ON-SITE SEWAGE DISPOSAL SYSTEM HOWARD COUNTY HEALTH DEPARTMENT BUREAU OF ENVIRONMENTAL HEALTH

Colette Henriette IS PERMITTED TO INSTALL ALTER

ADDRESS: 804 Bennett Road PHONE NUMBER: 301-829-9327

SUBDIVISION: Farmington LOT NUMBER: 1

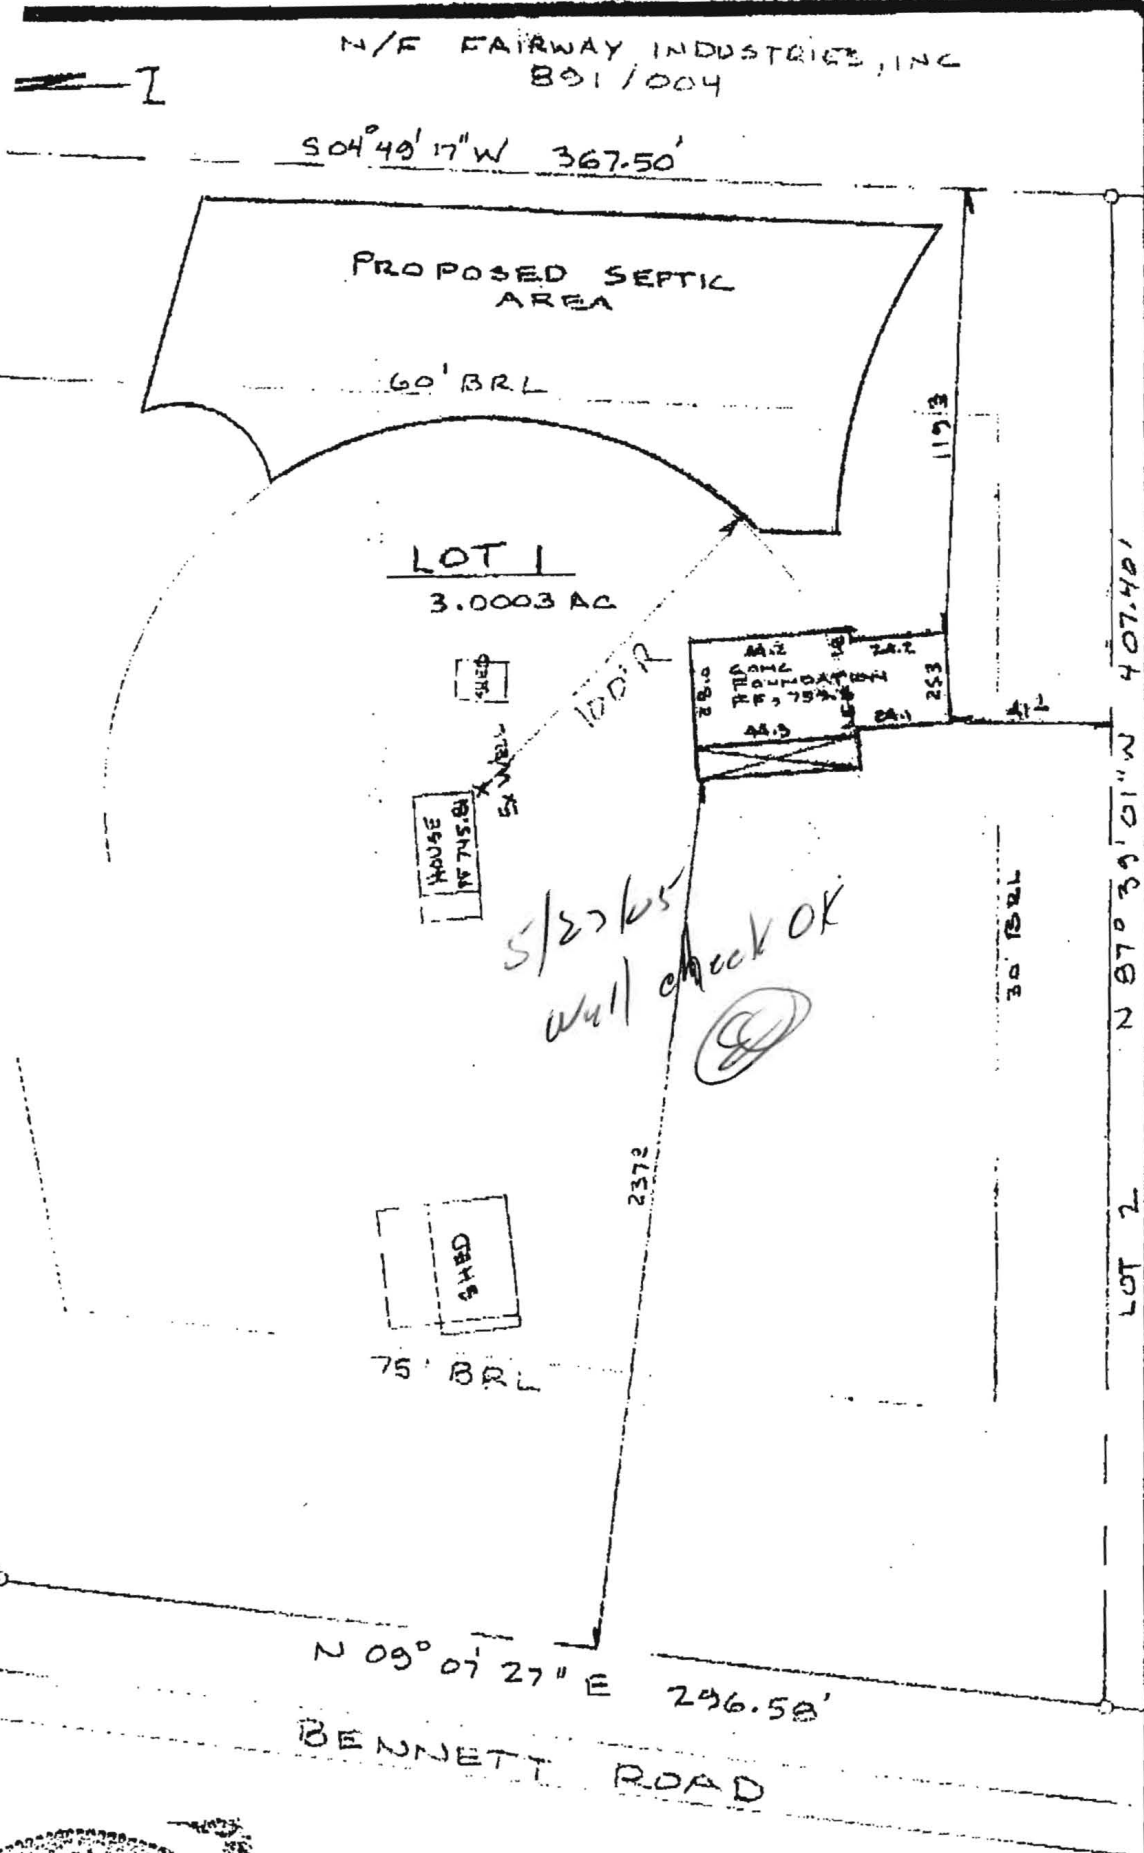
PRE-CONSTRUCTION 5 DA staked, contour appears to be okay. Set tank 15' from house w/ (3) 70' trenches. (SF/KB) 6/30/05.

INSTALLATION Two trenches have been dug. First trench covered, but left end open where septic tank connection will be. Trenches are approximately 75' long and are 3" wide. Second trench was being covered with stone. 6/30/05 (SF/KB)

7/1/05 4" c/b inside of house. Okay to cover everything. (SF/GAC)
